# PLANNING AND ZONING CASE CHECKLIST

**Project Number: SP2019-044**  
**Project Name: Office Complex**  
**Project Type: SITE PLAN**  
**Applicant Name: ROSS RAMSAY**  
**Owner Name: JIMMY MCCLINTOCK**

**Project Description: Discuss and consider a request by Steven Reyes of Ramsay & Reyes, LLC on behalf of Jimmy McClintock of LMGC, LLC for the approval of a site plan for an office building on a 0.739-acre tract of land identified as a portion of Lot 14 of the Lowe & Allen Addition [0.4590-acres] and Lot 2-R, Block A, Washington Place Addition [0.28-acres], City of Rockwall, Rockwall County, Texas, zoned Downtown (DT) District, situated within the SH-66 Overlay (SH-66 OV) District, addressed as 409 W. Washington Street, and take any action necessary**

**TO:** Planning and Zoning Commission  
**DATE:** January 14, 2020  
**APPLICANT:** Steven Reyes; *Ramsay and Reyes Architecture, LLC*  
**CASE NUMBER:** SP2019-044; *Site Plan for 409 W. Washington Street*

DRAWING NAME:  
**PHOTOMETRIC SITE PLAN**

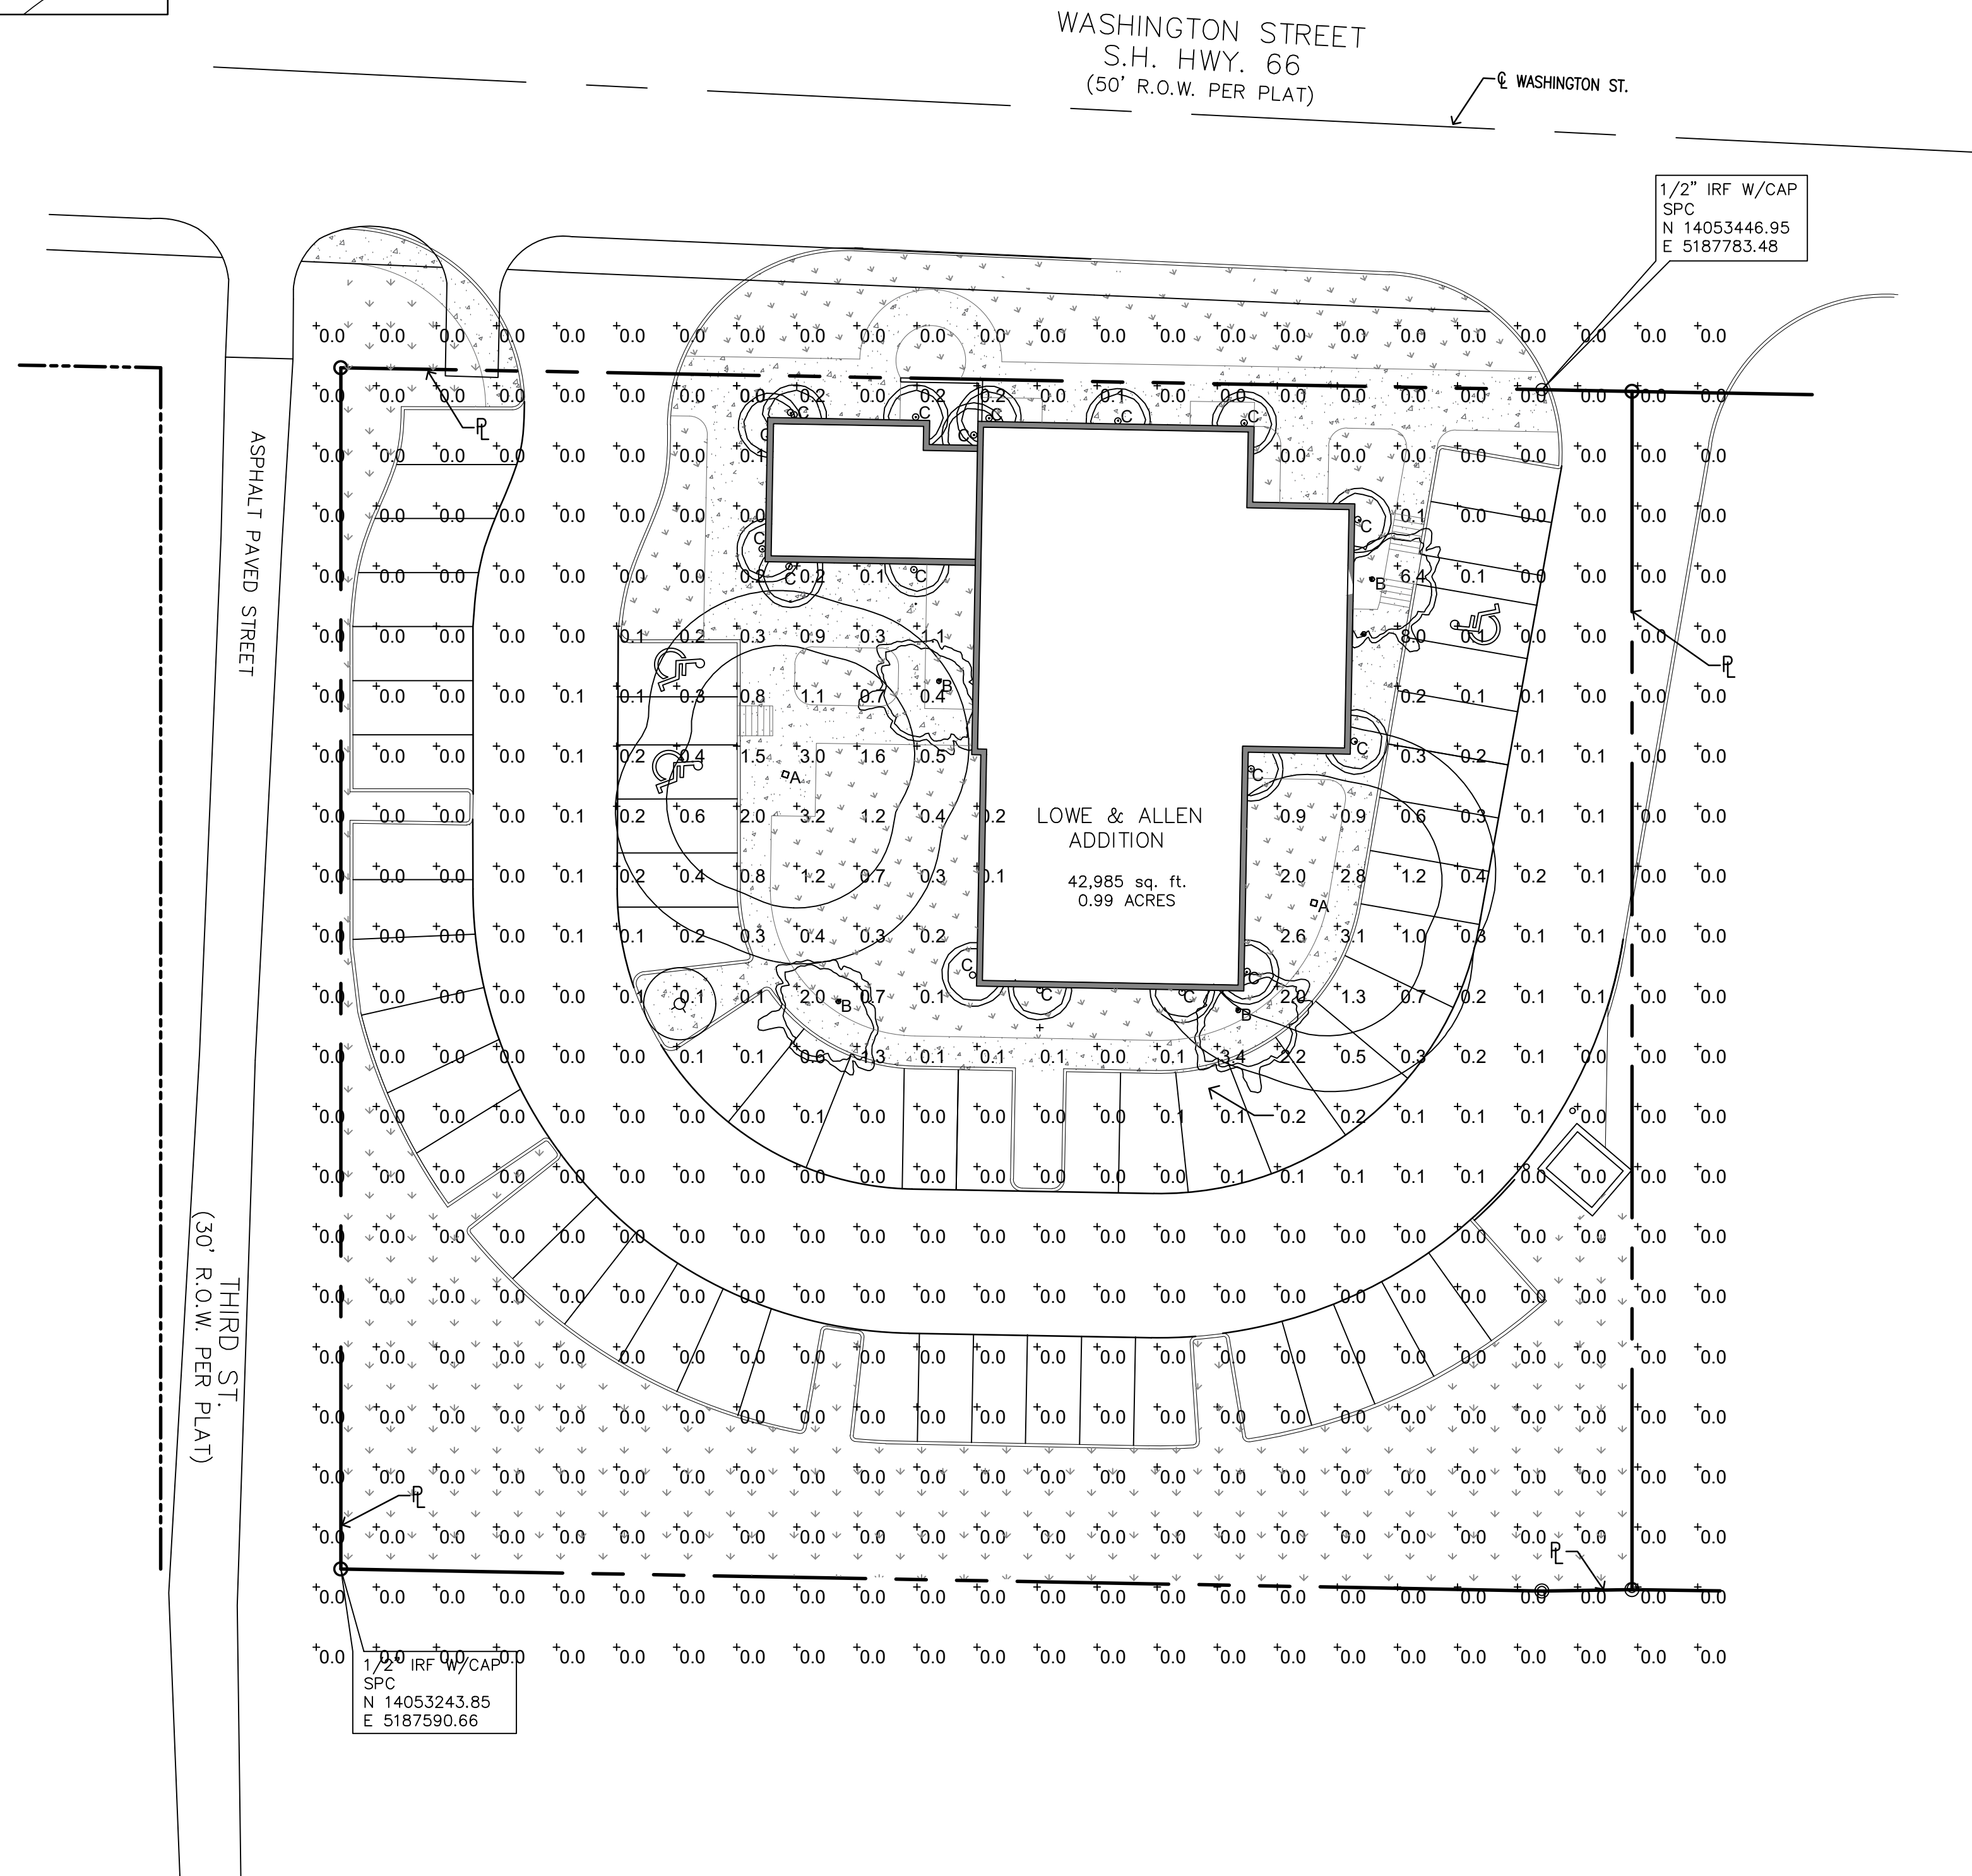
(34) Please show and label property line.						
(35) Please note, it is difficult to see location of fixtures. Please greyscale FC and bold the fixtures						
BUILDING ELEVATIONS

DRAWING NAME:  
**ELEVATION NORTH & SOUTH**

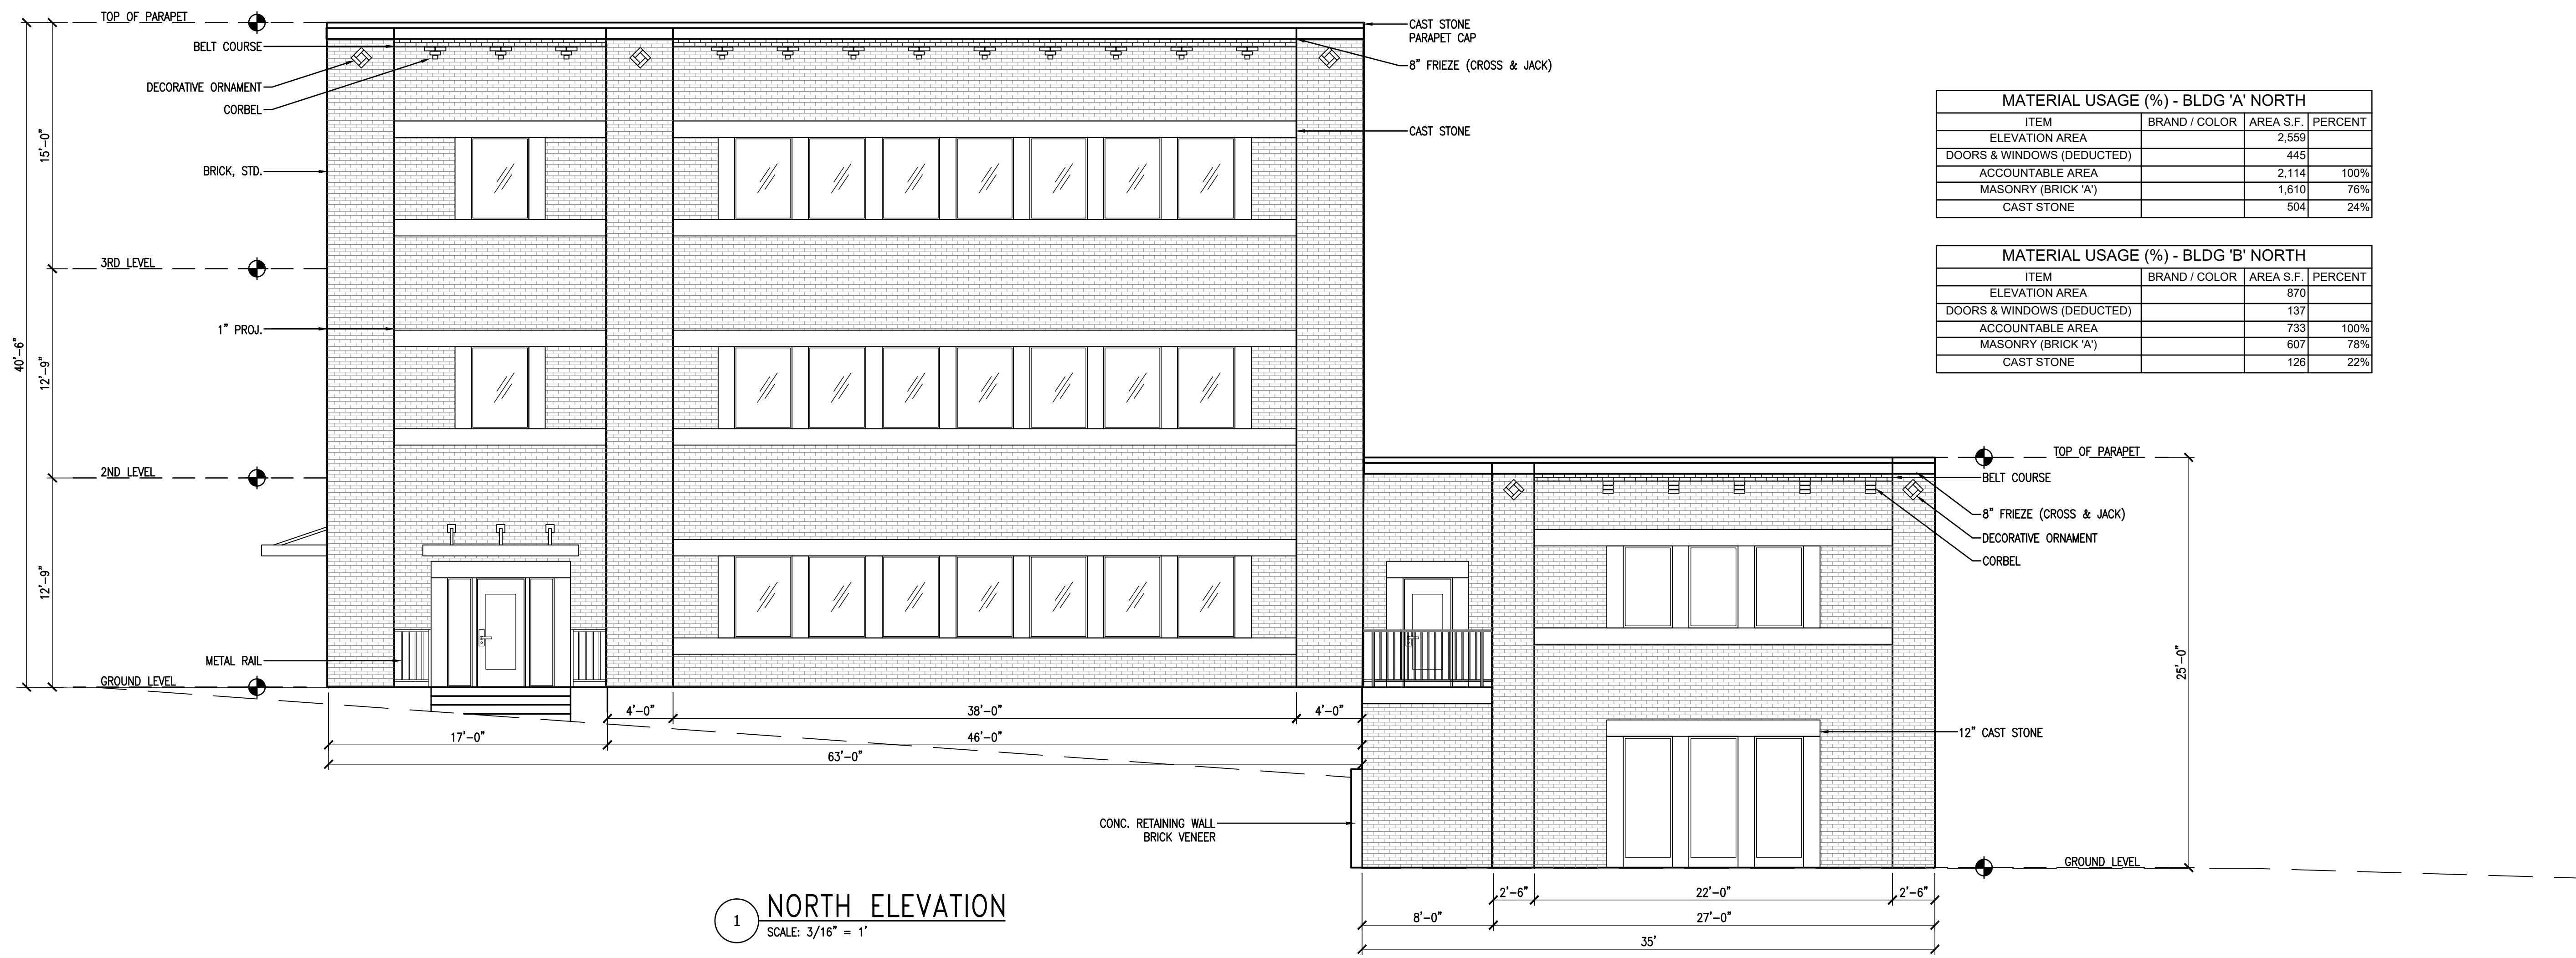
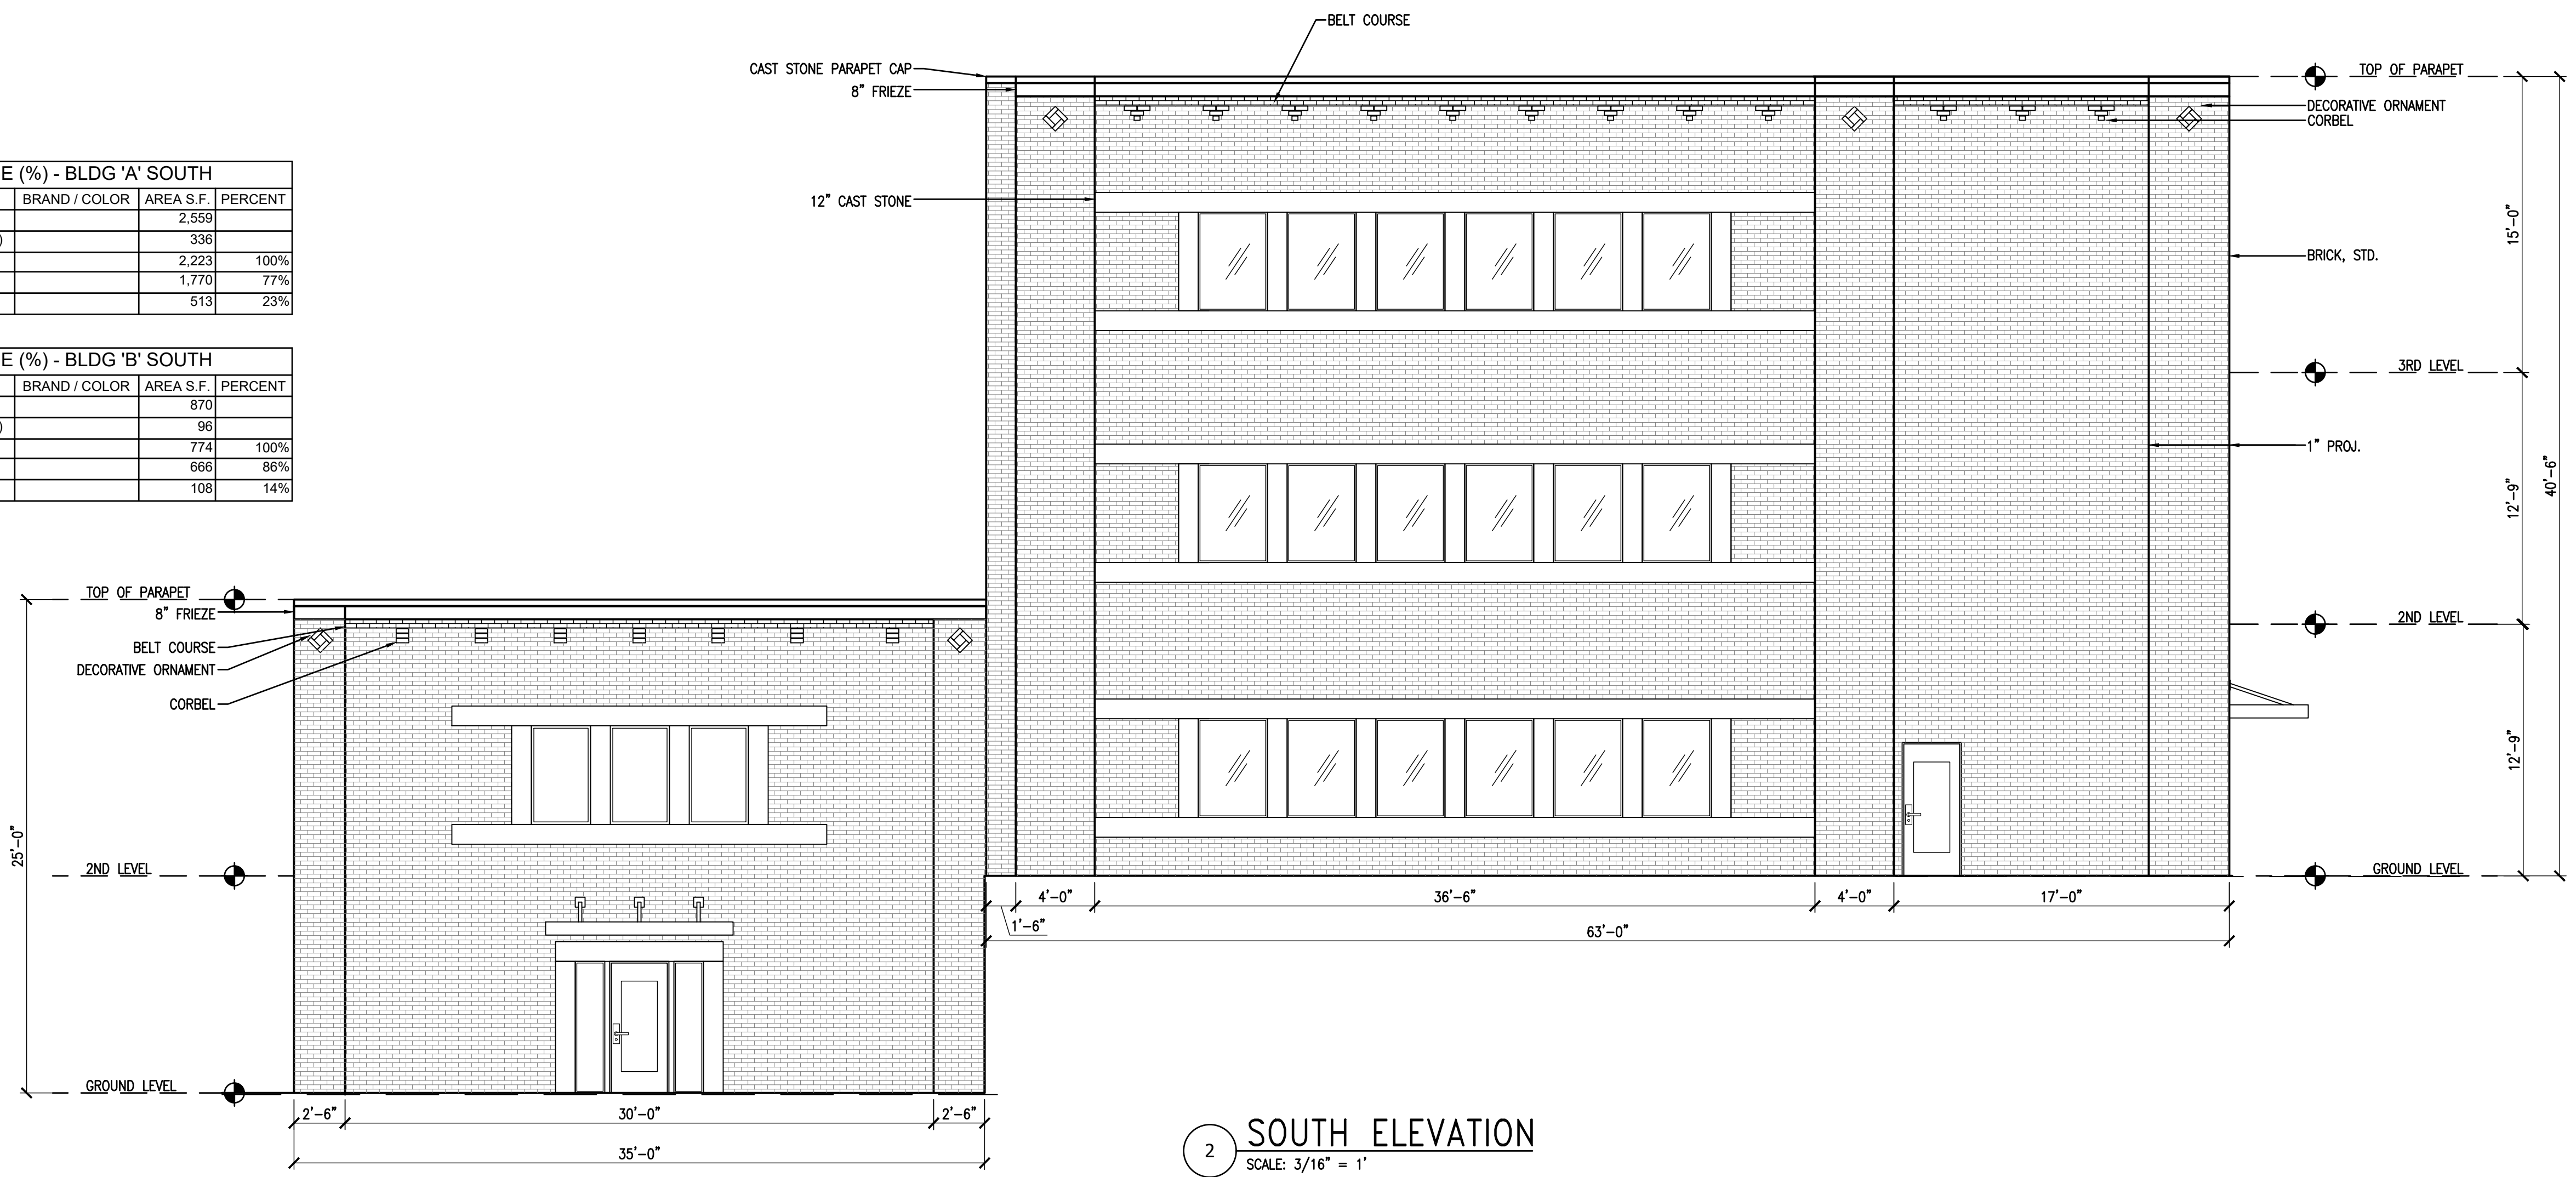
(36) Please note, that the one-story building is required to be two-stories min						
(37) What is the material below the stairs? Retaining wall? Please show and label.						
I.6 Please note that failure to address all comments provided by staff by 5:00 PM on December 3, 2019 will result in the automatic denial of the case on the grounds of an incomplete submittal. No refund will be given for cases that are denied due to an incomplete submittal, and a new application and fee will be required to resubmit the case.						
I.7 Staff has identified the aforementioned items necessary to continue the submittal process. Please make these revisions and corrections, and provide any additional information that is requested.						
o Revisions for this case will be due on December 3, 2019;						
o The Planning & Zoning Worksession is November 26, 2019.						
o The Planning and Zoning Commission Meeting for this case is December 10, 2019
